STAFF REPORT

SUBJECT: FP-2021-0017
Tetherow Crossing Final Plat

LOCATION: The site is located northeast of N. Linder Rd and W. Ustick Rd

B. Final Plat (date: 2/17/2021)

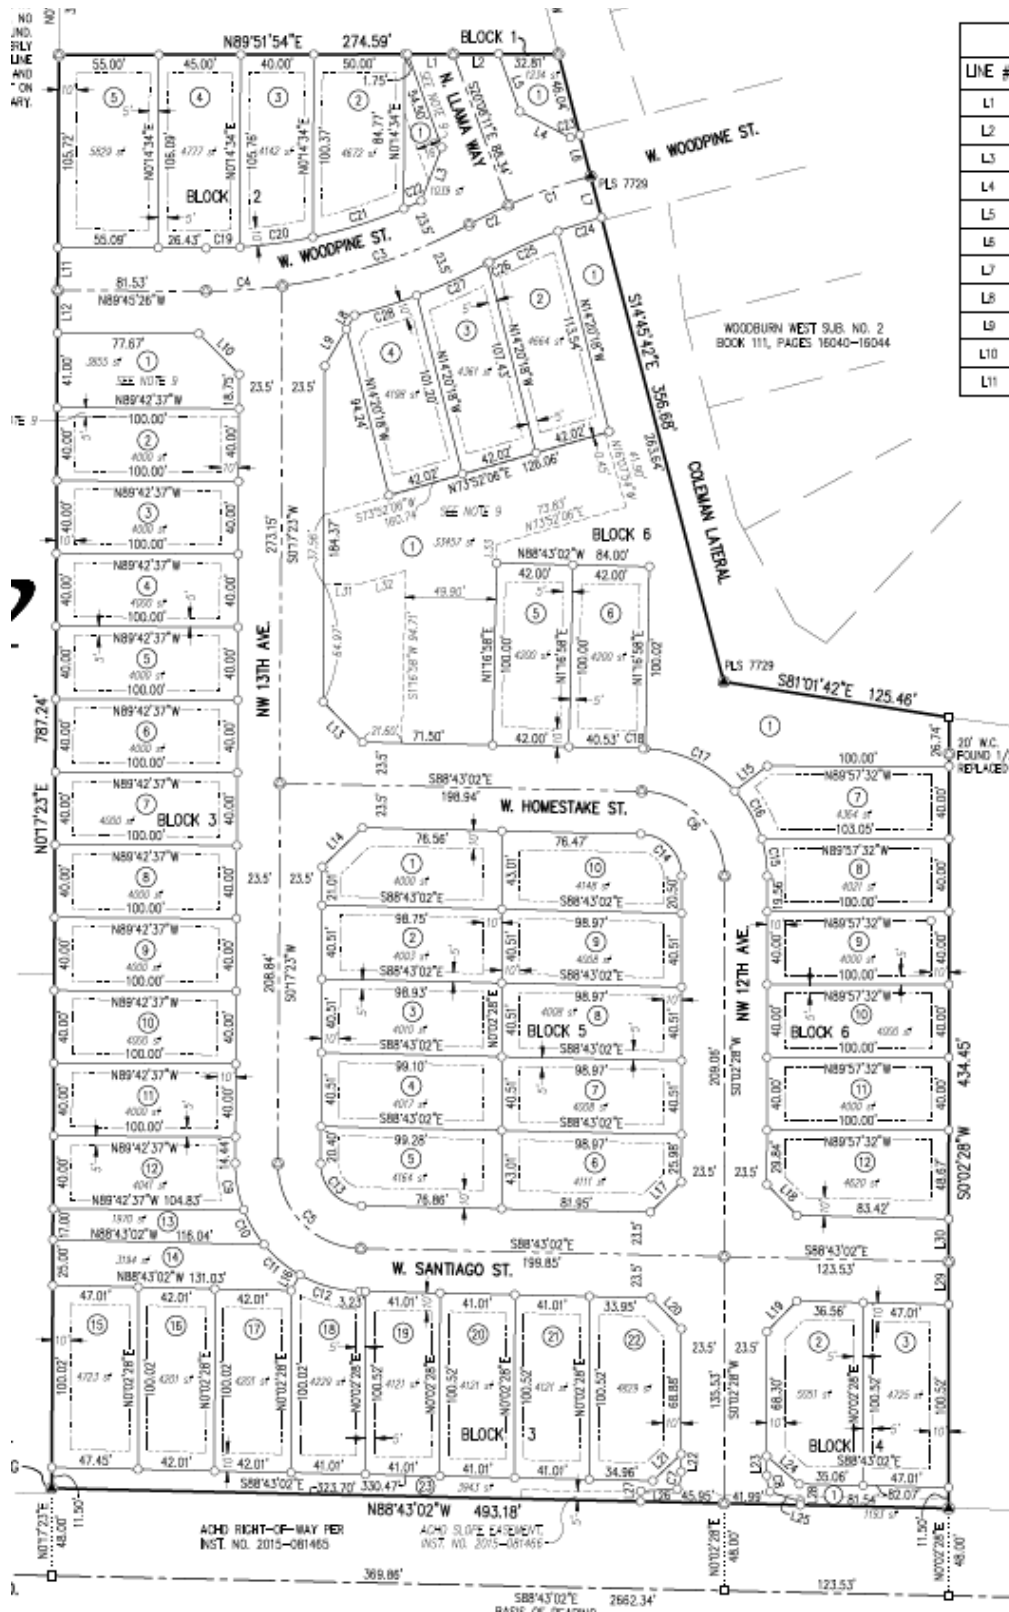
3. Prior to City Engineer signature on the final plat, the final plat prepared Land Solutions, stamped by Clint W. Hansen, dated: 02/17/2021, included in Section V.B shall be revised as follows:

- a. Add a note that Lots 2-5, Block 2 are limited to one story.
 - b. Note 12, add Instrument Number.
 - c. Note 13, add ACHD Instrument Number.
4. The landscape plan prepared by Jensen Belts Associates on February 17, 2021 is approved as submitted.
